HORSHAM DISTRICT COUNCIL CONSULTATION

TO:	Horsham District Council – Planning Dept
LOCATION:	Greenway Academy Greenway Horsham West Sussex
DESCRIPTION:	Application for Approval of Details Reserved by Condition 3, 4, 5 and 6 to approved application DC/22/1954
REFERENCE:	DISC/26/0153
RE-CONSULT:	1 st set of comments in black 2 nd set of comments in blue
RECOMMENDATION:	Condition 3: More information No objection Condition 4: More information No objection Condition 5: Modification No objection Condition 6: No comments

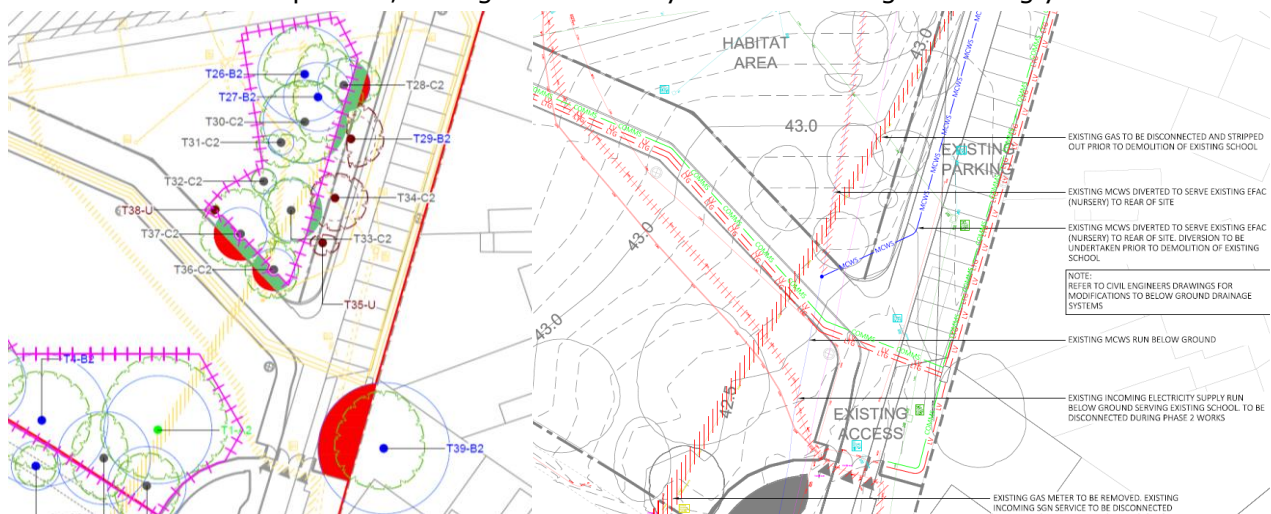
3. Some discrepancy is noted within the documentation provided. For example, the existing gas is proposed to be stripped out prior to demolition of the existing building, however this is not reflected in the tree protection fencing (TPF) layout. The stripping of this utility run is recommended against given its placement within mature tree groups and particularly Cat A T1. Please explore if it can be decommissioned and left in situ instead. If it cannot, the description of sensitive methods to limit harm to the trees is requested, noting that TPF may need amending accordingly.

Gas is confirmed to be left in situ and the TPF has been amended accordingly, with thanks. Closed.

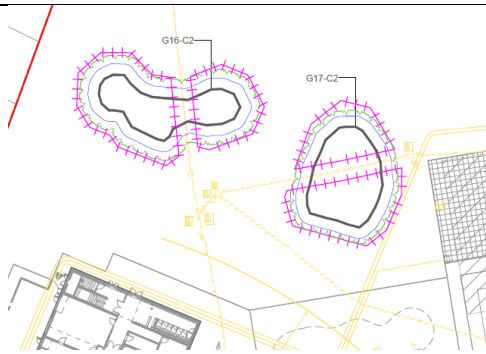
4. It is noted that TPF is proposed within the tree groups, below, either side of the existing drainage run. These runs are not proposed to be removed, thus the TPF should be amended accordingly.

Amended, with thanks. Closed.

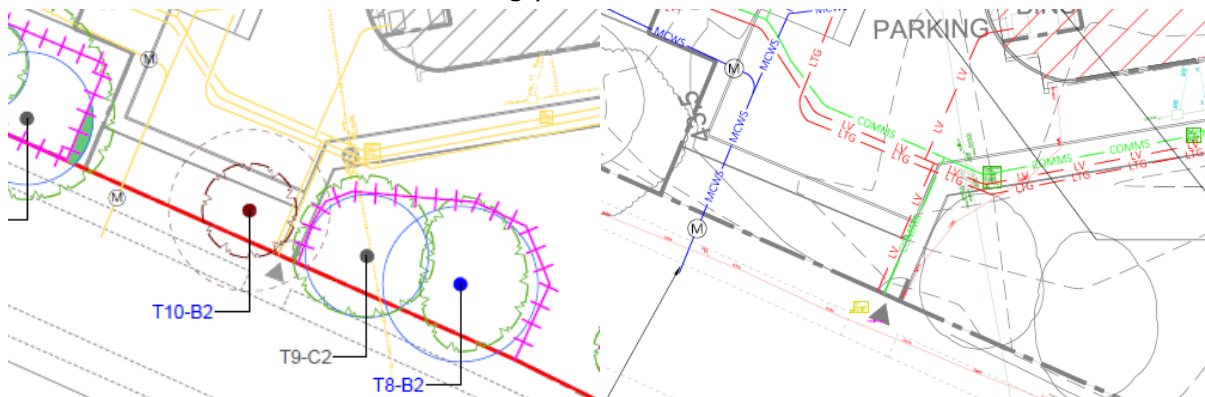
5. T9 is included within the tree removal schedule but appears to be retained in plan. No development appears to be proposed within its RPA, thus its retention is requested in order to limit erosion of the well treed townscape character and in order to provide benefits to visual amenity in screening proposed built form and massing. Please amend the schedule accordingly.

Amended, with thanks. Closed.
